Appendix "D" - Recommended Second and Third Reading Alterations to the Public Markets Major Redevelopment Site "D" Secondary Plan

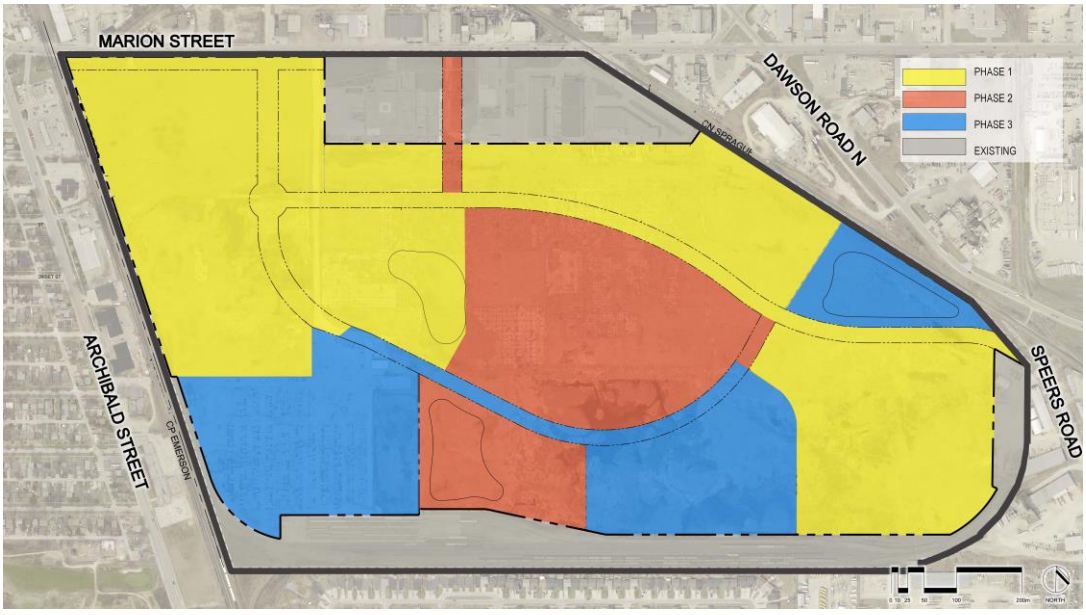
89.	Delete Figure 5 – Phasing Map and replace with the following: 
90.	Renumber *Figure 5 – Phasing Map* to *Figure 3 – Phasing Map* and renumber Figures in the Table of Contents and throughout Secondary Plan accordingly.
